MONMOUTH COUNTY PLANNING BOARD

Site Plan Action

Our File #: BBSP10155

known as 501-511 Lake Terrace

VC comments
5/19/21
1"=20'
(on '11x17 paper)

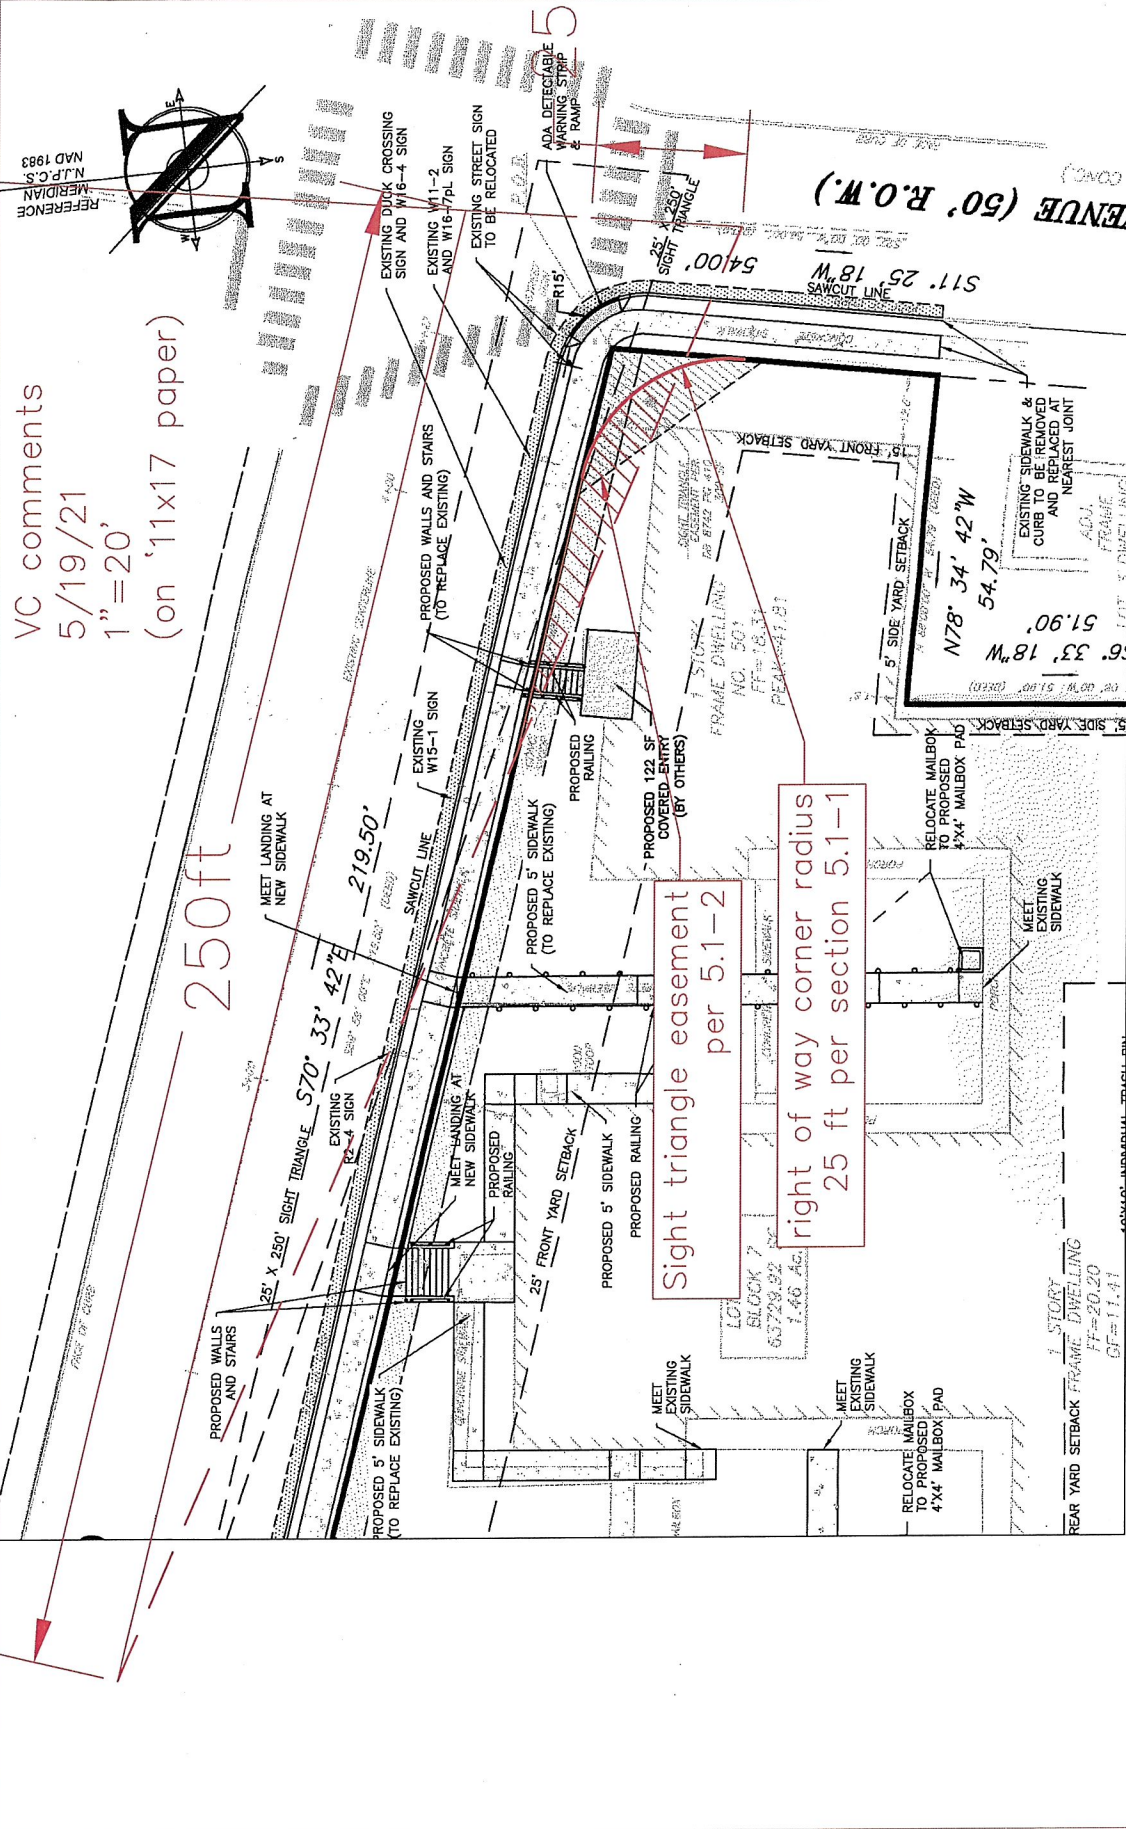
1. Revise the plans to show a right of way radius per the development regulations. The applicant's response letter references a physical corner radius at the intersection of Lake Terrace and Fletcher Lake Avenue. Comment #1 in the 4/12/2021 action letter referred to §5.1-1 of the county's development regulations, which requires a 25-foot right-of-way radius as shown on the attached mark-up. The markup indicates it will not conflict with any existing building.

2. Revise the site plan to show a 25-foot x 250-foot sight triangle per §5.1-2 of the Monmouth County development regulations. The sight triangle easement shown on the plan was not drawn correctly. Per §5.1-2 the sight triangle is drawn as: "The area bounded by the right-of-way lines of the county road and proposed road or street and a straight line connecting a point measured along the centerline of the proposed road or street 25 feet the edge of pavement of the county roadway and a point on the center of each lane of the county road that approach the intersection a measured distance that equals 10 times the posted speed limit". A sight triangle easement drawn to the above dimensions is shown on the attached mark-up.

Sight triangle easement
per 5.1-2

right of way corner radius
25 ft per section 5.1-1

ATTACHMENT 1

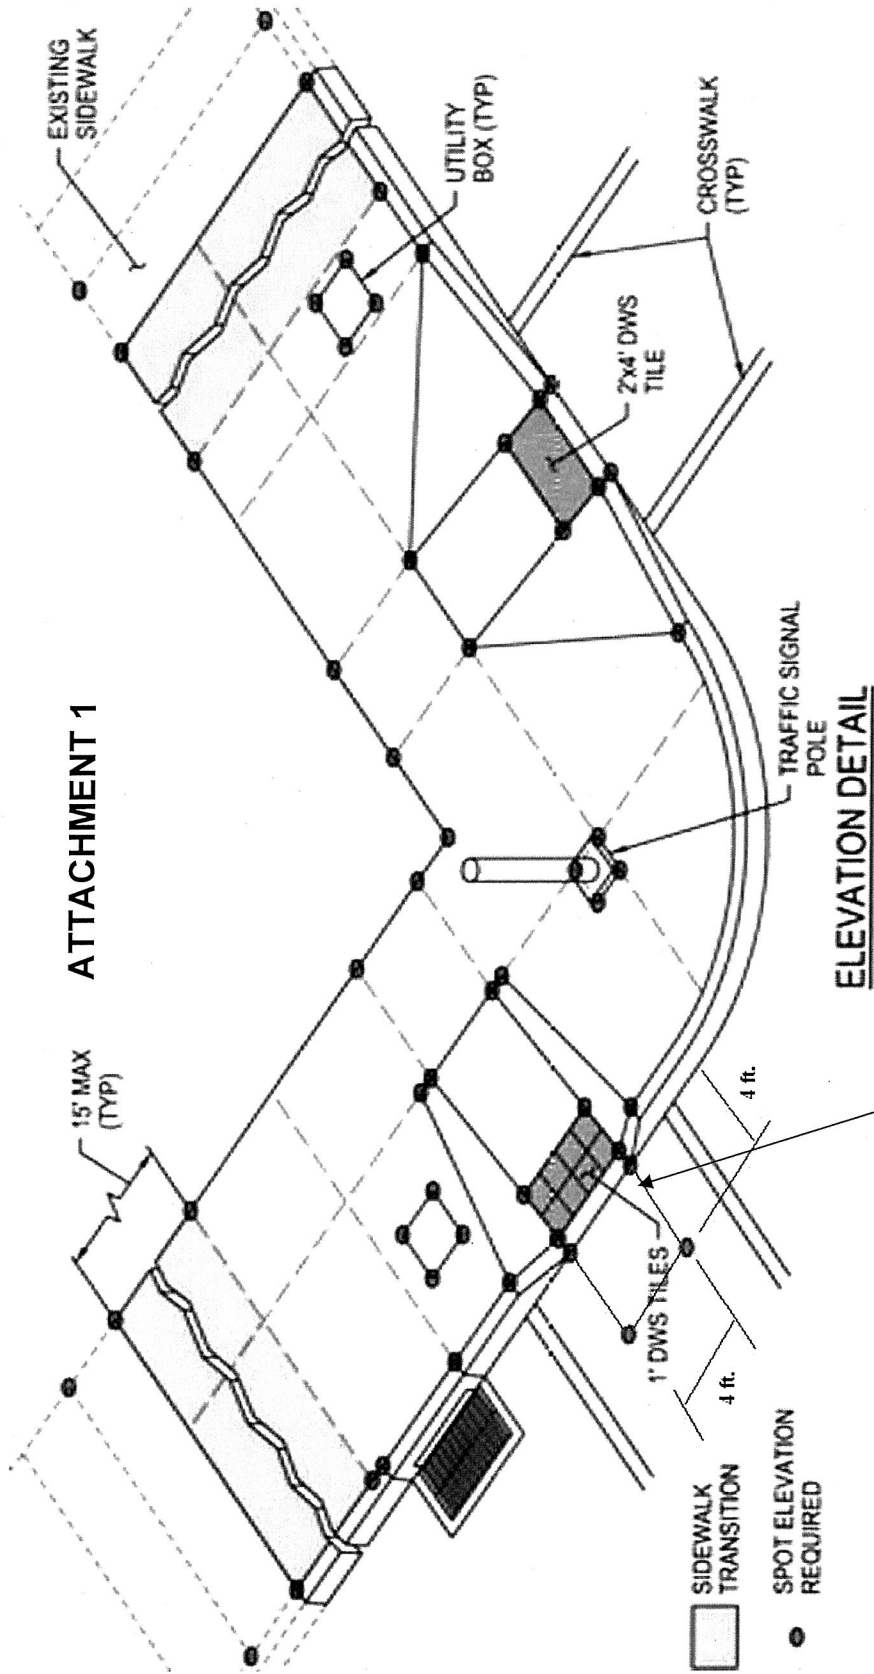
- a. Provide spot elevations at top and bottom of all existing and proposed curb ramps; at corners of detectable warning surfaces, and associated landing / maneuvering areas; at corners of all transition areas, and at corners of ramp flares, as indicated on Attachment 1.

IF RAMP IS NOT DIRECTIONAL, MUST PROVIDE 4-ft. x 4-ft. TURNING AREA ON PAVEMENT, AT MAX. 2% SLOPE IN BOTH DIRECTIONS. SEE ATTACHMENT 2

ATTACHMENT 2

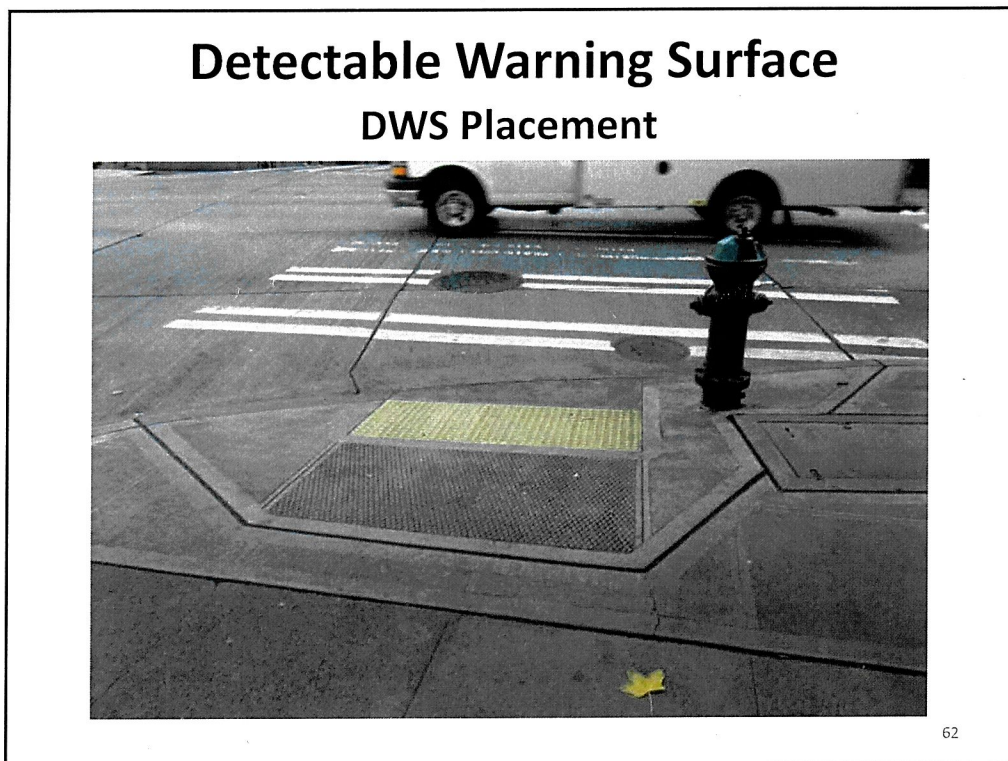
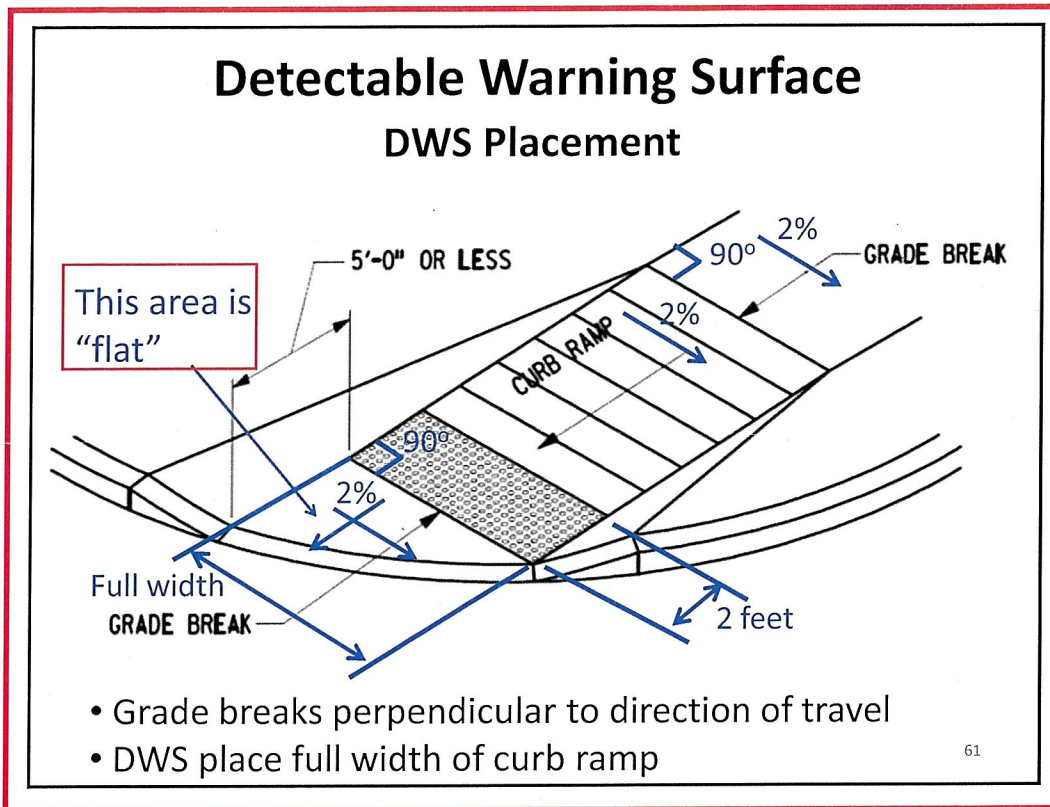
- b. Indicate that all changes in longitudinal / running slope are perpendicular to the direction of the associated sidewalk and that all cross-slopes are at maximum 2%, as indicated in Attachment 2.

ATTACHMENT 3

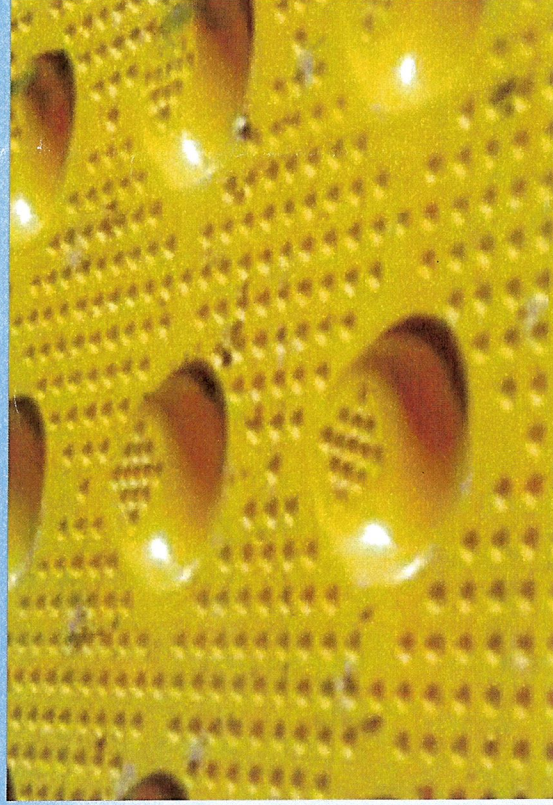
- c. Indicate that all detectable warning surfaces are located at the lower end of each curb ramp, as shown on Attachment 3. Indicate that the lower edge of each detectable warning surface is 6 to 8 inches from the face of curb, or adjacent to the back of curb, as shown on Attachment 3A.

Placed across the bottom of the curb ramp. Full width of ramp

ATTACHMENT 4

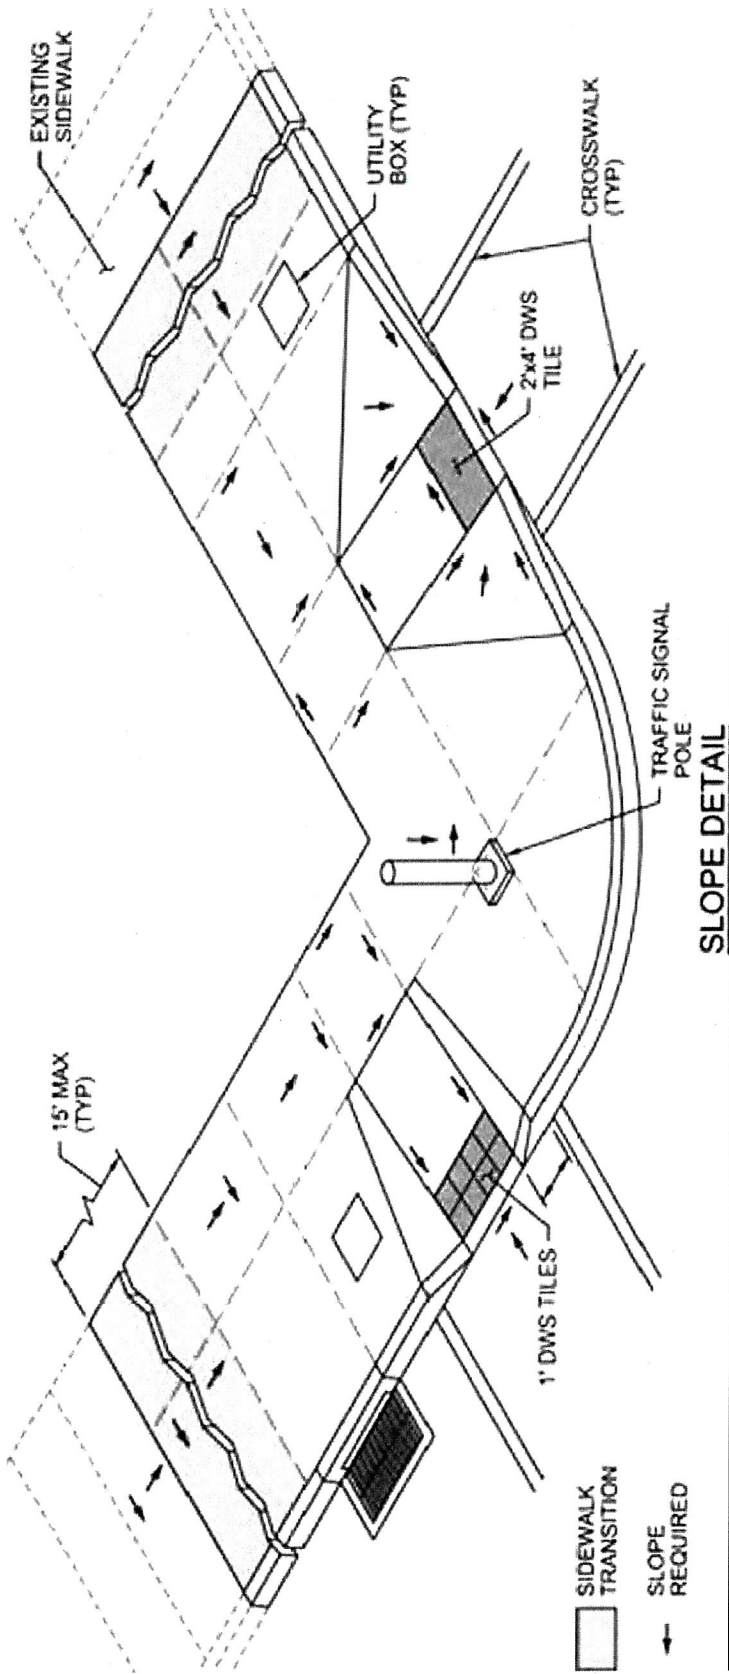
- d. Provide computations to verify that all longitudinal / running slopes are at maximum 8.33% (1V:12H) and that all cross slopes are at maximum 2% at locations indicated on Attachment 4. Use design slopes of 7.5% and 1.5% respectively, to allow for construction tolerances.

ATTACHMENT 5

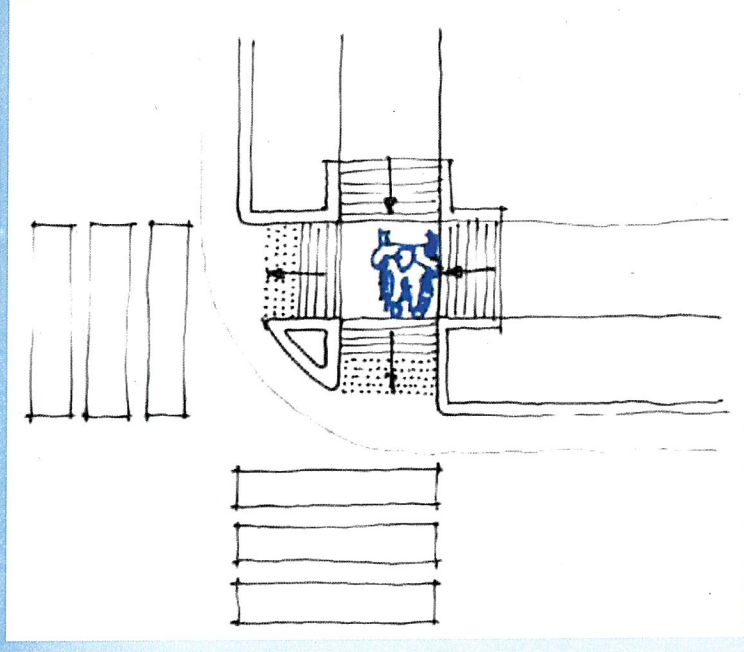
- e. Indicate that curb ramps within the right-of-way of Lake Terrace are aligned with crosswalks, as indicated in Attachment 5.

Ramps must be aligned with crosswalks to help wheelchair users orient themselves to cross the street

ATTACHMENT 6

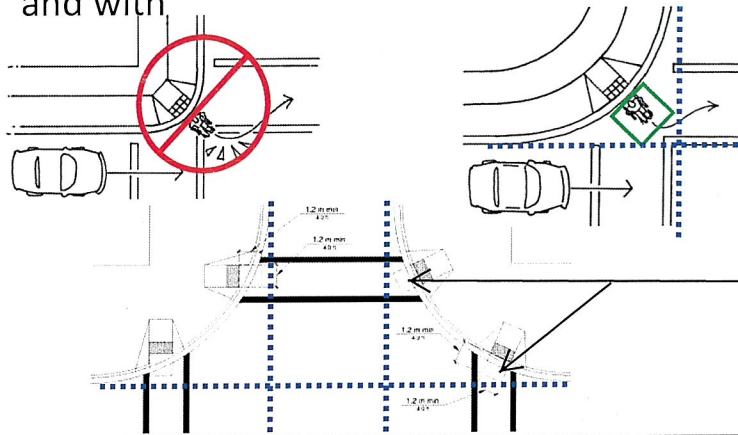
- f. If curb ramps are not aligned with crosswalks, provide 4-foot by 4-foot turning area with maximum 2% slope, as indicated in Attachment 6. Incorporate the attached curb cradle detail into the detail sheet(s).

Curb ramps shall also have clear space at the bottom of ramp that is level (2% max), and wholly outside of vehicle travel lanes and with

IF RAMP IS NOT DIRECTIONAL, MUST PROVIDE 4-ft x 4-ft TURNING AREA WITH MAX. 2% SLOPE IN ALL DIRECTIONS, OUTSIDE VEHICLE TRAVEL LANES, WITHIN CROSSWALK LINES
